Field Observation Report

PROJECT: 4600 Silver Hill Rd Parking Garage

WALTER P MOORE PROJECT NO. D01.20007.00

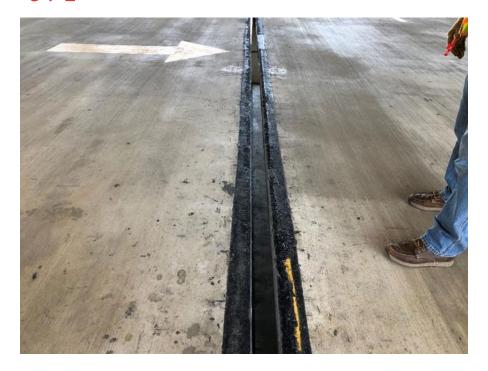
04-2. Isolated locations of partial-depth concrete slab repair were observed at Levels 1 and 2 of the north garage (Photo 04-5). The repairs were observed to be sound, flush with the existing slab surface and to have squared edges.

Action: None.
